**AMPLIFIER, R.F., No. 2  
MODIFICATIONS  
MODIFICATION INSTRUCTION No. 1**

(Amplifier, R.F., No. 2, Mk. I)

### MODIFICATION INSTRUCTION NO. 2

(Amplifier, R.F., No. 2, Mks. I and II)

**Fig. 1—Amplifier, R.F., No. 2, fitting of ceramic condenser Y24B**

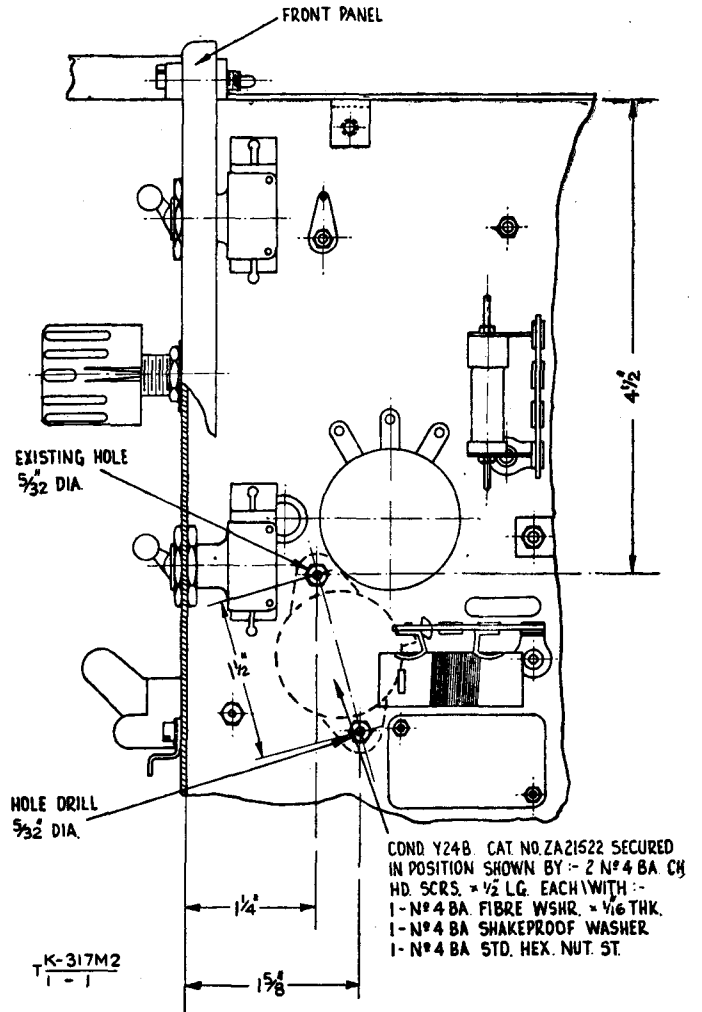
5. (a) Condenser Y24B has been fitted to Amplifier, R.F., No. 2, Mk. II, as the previous type of condenser (condenser Y24A) was not capable of withstanding the high R.F. voltage and temperatures encountered. Consequently it has been decided to provide the new type of condenser for the maintenance of Amplifier, R.F., No. 2, Mks. I and II. The following modifications will be necessary when replacing condenser Y24A by condenser Y24B.

- (b) C6A-D is located on top of the chassis immediately behind the set-flick mechanism.
  - (c) Remove condensers Y24A (four condensers complete with bracket).

- (d) Remove the input coil, L1A, to avoid damaging it in the subsequent drilling operation.
  - (e) Drill one hole  $\frac{5}{32}$  in. dia. (22 drill) as shown in Fig. 1.

- (f) Mount the new condenser and connect up (normally the horizontal condenser tag is connected to the chassis end of the P.A. coil and the vertical one to the top end).
